NORTH SALT LAKE PLANNING COMMISSION NOTICE & AGENDA July 14, 2020 6:30 p.m.

TO: Planning Commission
FROM: Sherrie Llewelyn, Community Development Director
DATE: July 14, 2020
SUBJECT: Consideration of a conditional use permit for Ornamental Elegance at 905 North Main

TO: Planning Commission
FROM: Sherrie Llewelyn, Community Development Director
DATE: July 14, 2020
SUBJECT: Consideration of a conditional use permit for Design Space at 147 East Union Ave.

TO: Planning Commission
FROM: Sherrie Llewelyn, Community Development Director
DATE: July 14, 2020
SUBJECT: Site Plan Amendment for Tim Dahle Nissan at 955 North 400 East

Site Plan
Design Space Modular Buildings
147 East Union Avenue
North Salt Lake City, Utah

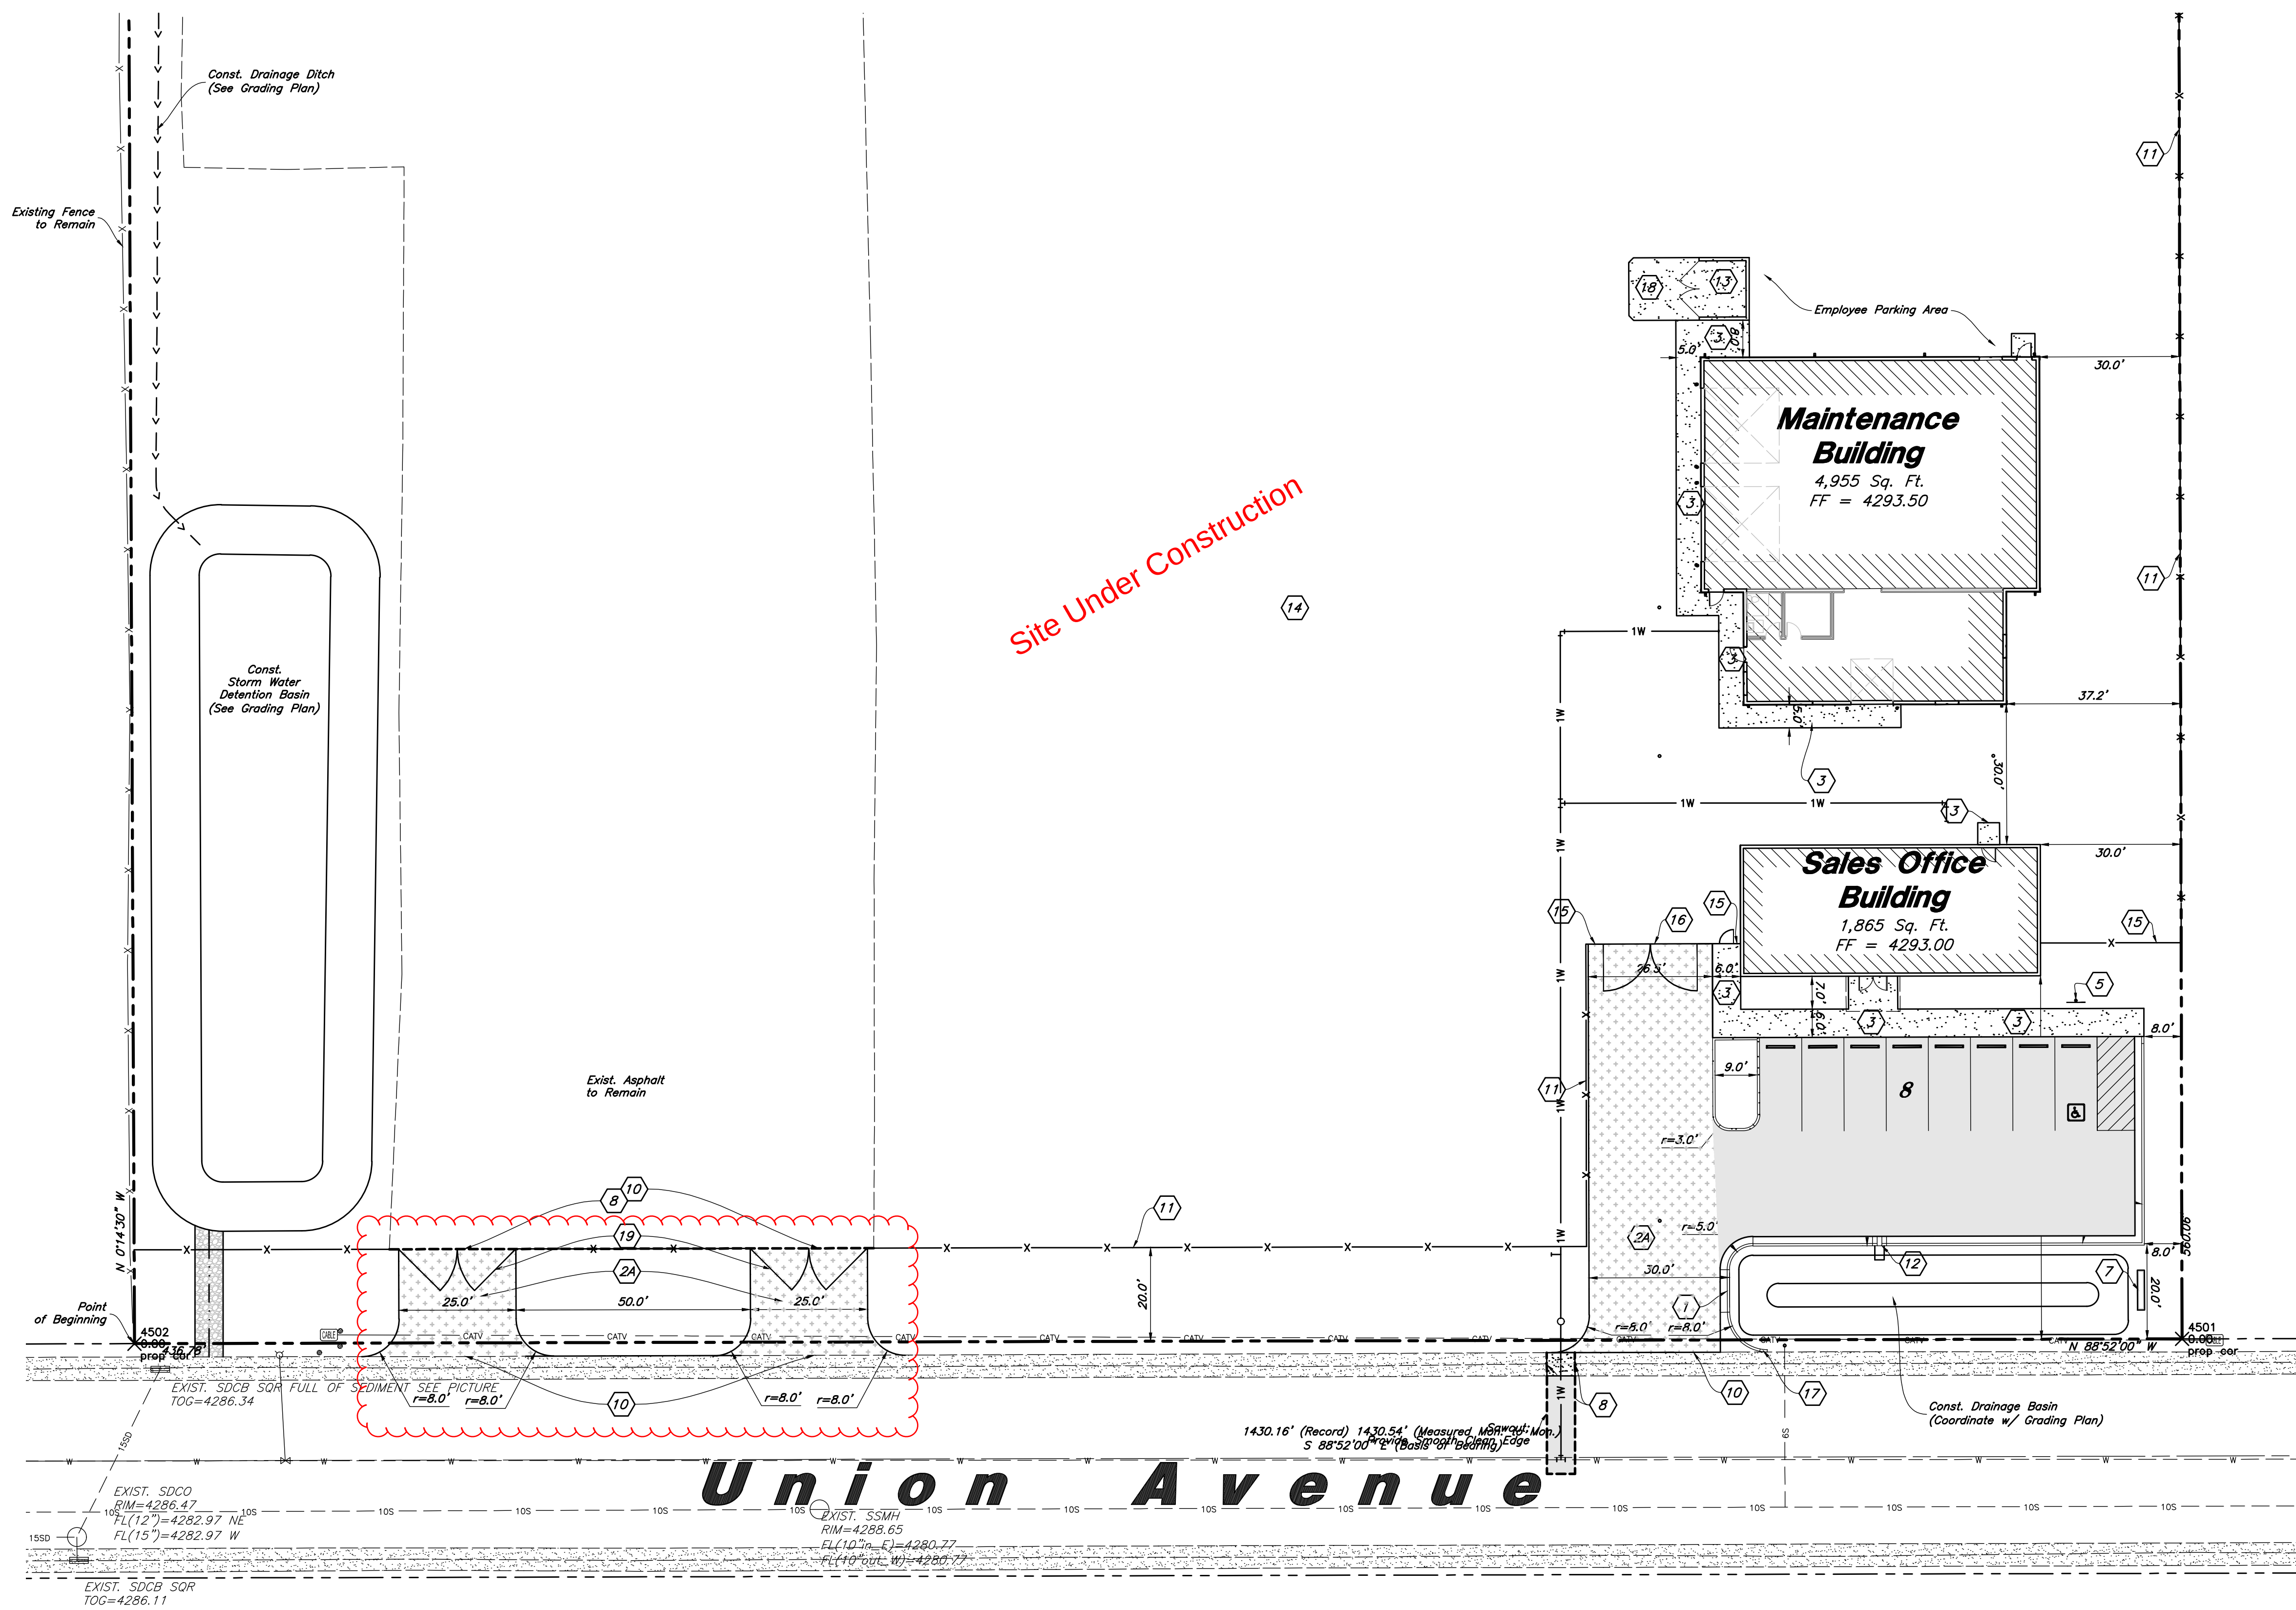
The property has approximately 435 feet of frontage. The proposed additional 3rd driveway is amending the previously approved 40' driveway into two 25' driveways with a minimum separation distance of 50'. The purpose of the separation will allow trucks delivering or picking up materials from the site to enter via one gate and exit via the second gate. The City Engineer has reviewed the application and determined that the 3rd driveway access will not create a traffic hazard or unreasonable impediment to traffic flow, given the street is a local street and a dead end street.

A1 WEST BUILDING ELEVATION
SCALE: 1/8" = 1'-0"

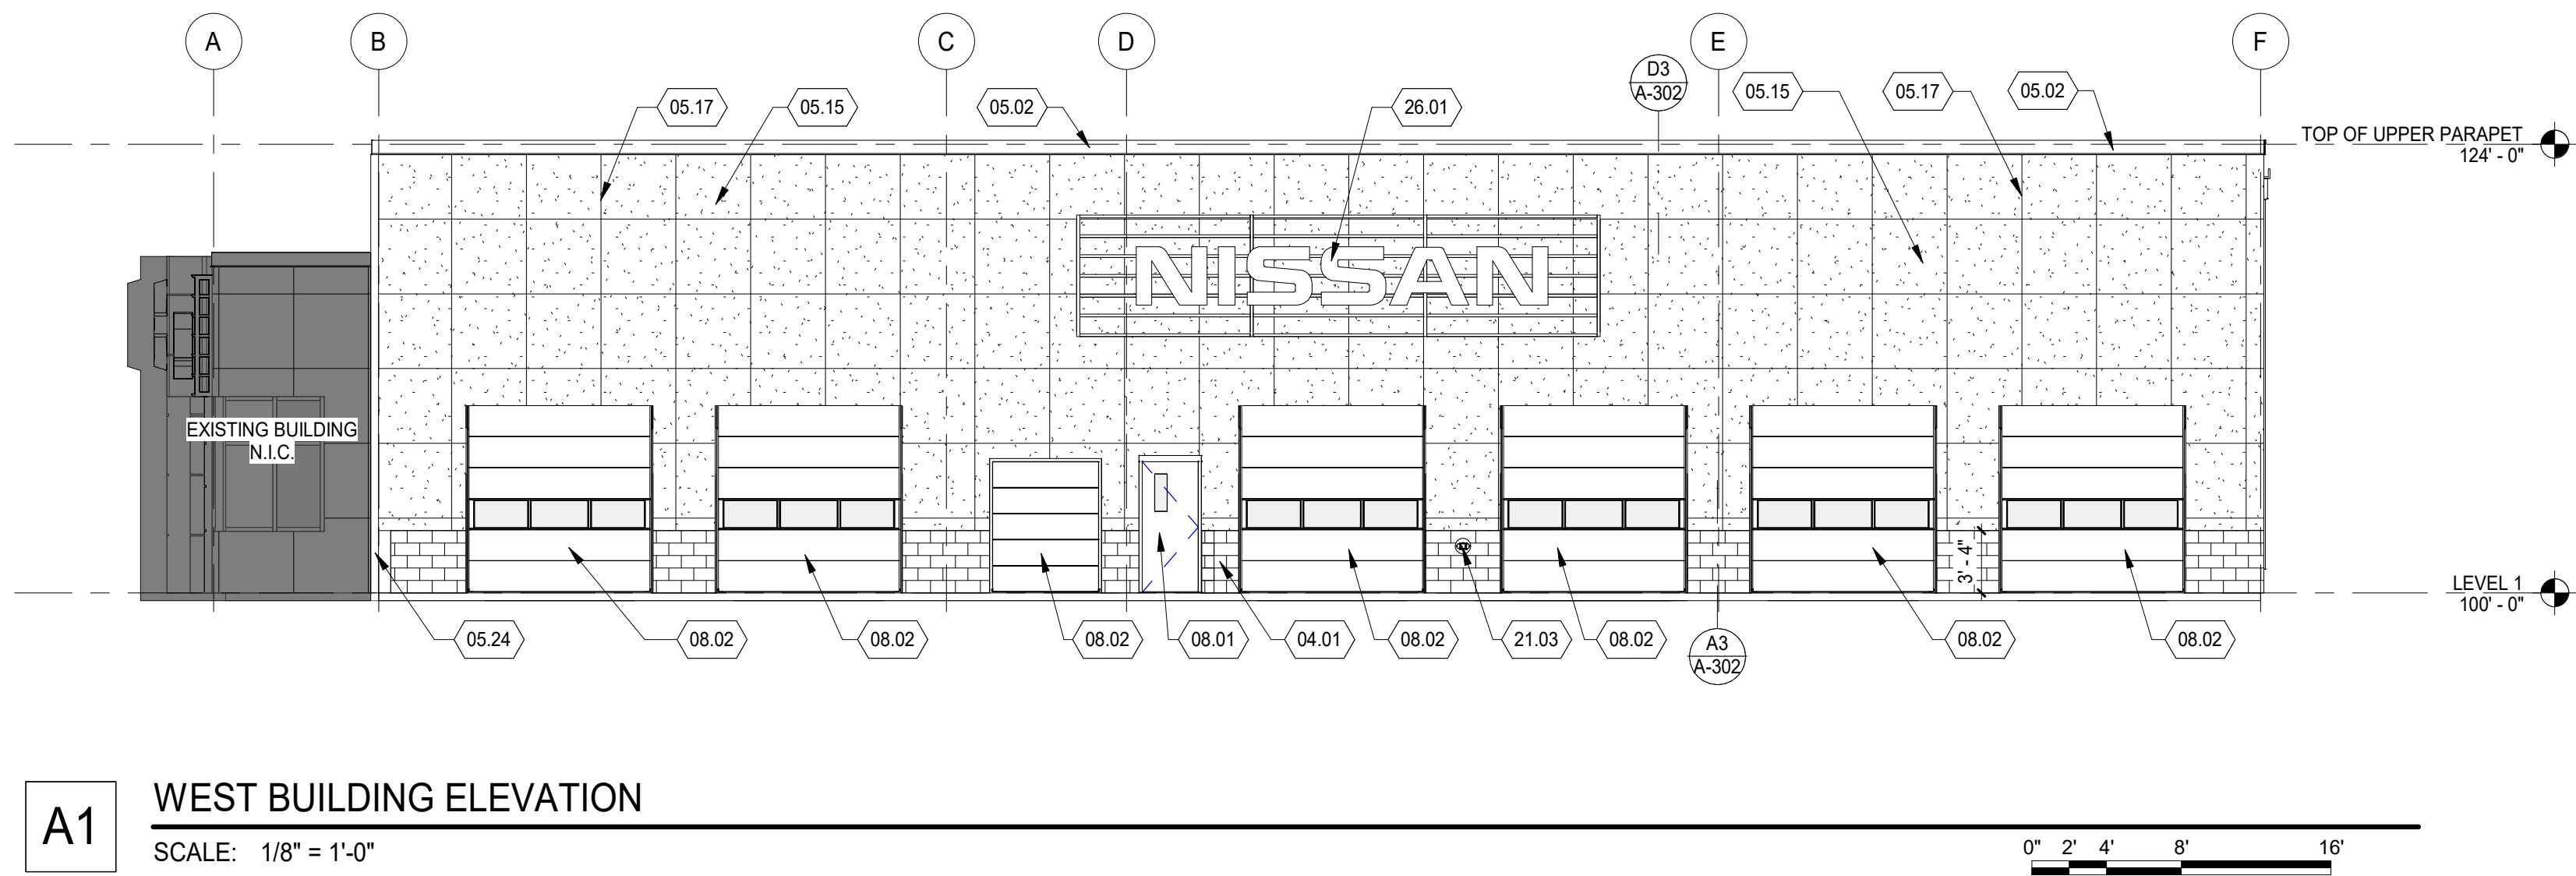
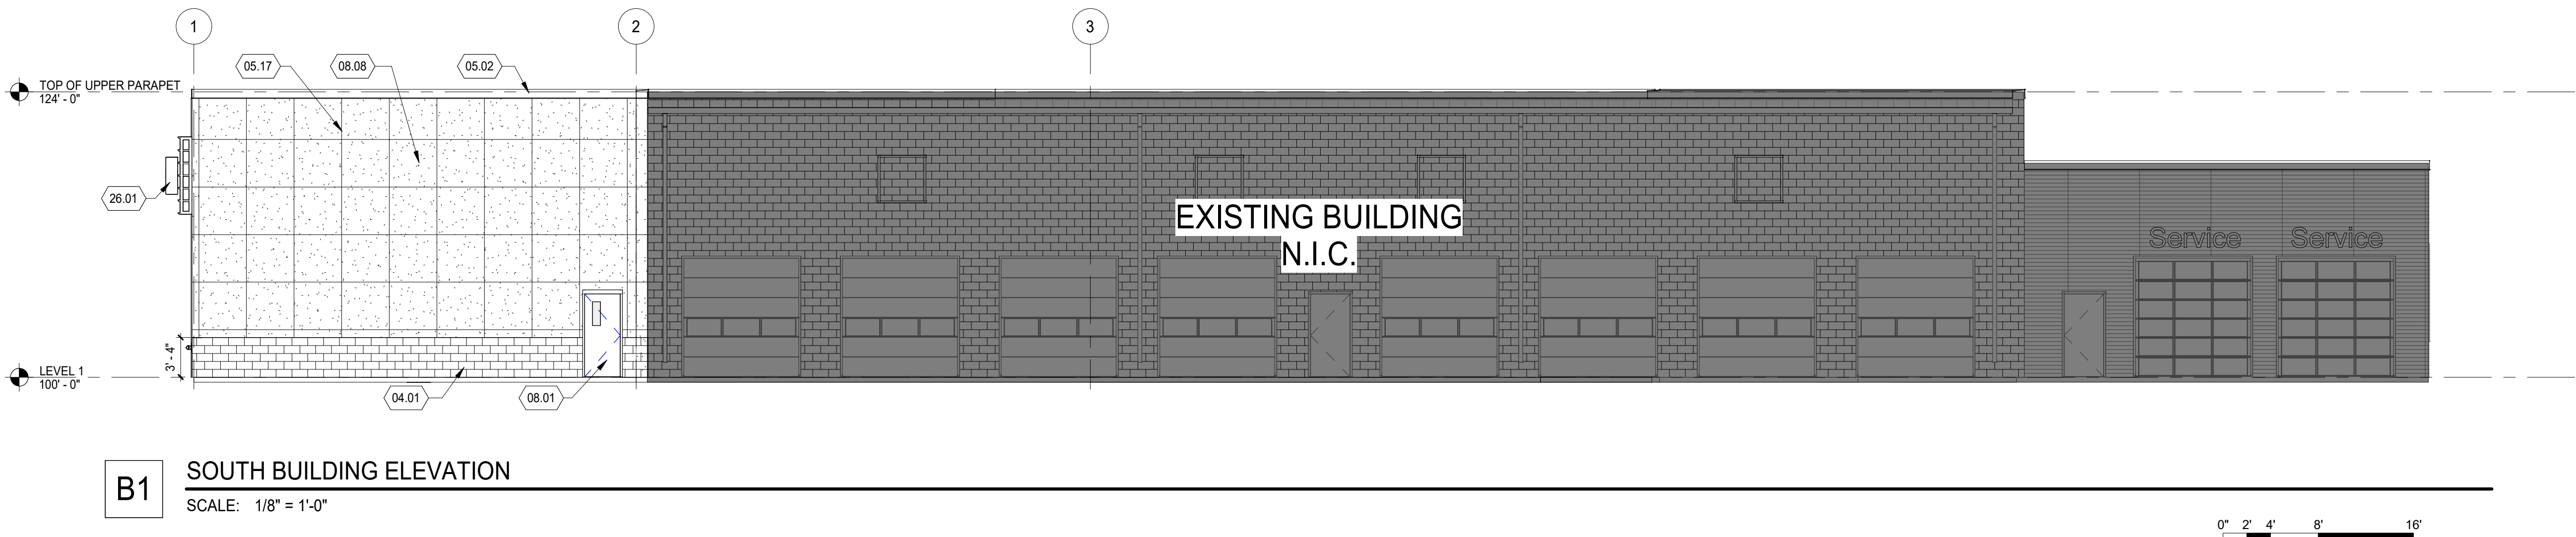
1. The rear elevation (west) facing I-15 be modified to provide parapet variation of 2 feet for roof lines longer than 60 feet;

- Vertical Articulation every 30 feet in height-max height 30 feet
(meets standard)
- Parapet Variation every 60 linear feet-*All facades visible from a public right of way shall include a parapet that varies in height by at least two feet (2') for each sixty (60) linear feet of facade length. The facade is 100 feet long and must have a parapet variation of 2 feet every 60 feet.*
(DOES NOT MEET standard)

1. The rear elevation (west) facing I-15 be modified to provide parapet variation of 2 feet for roof lines longer than 60 feet.
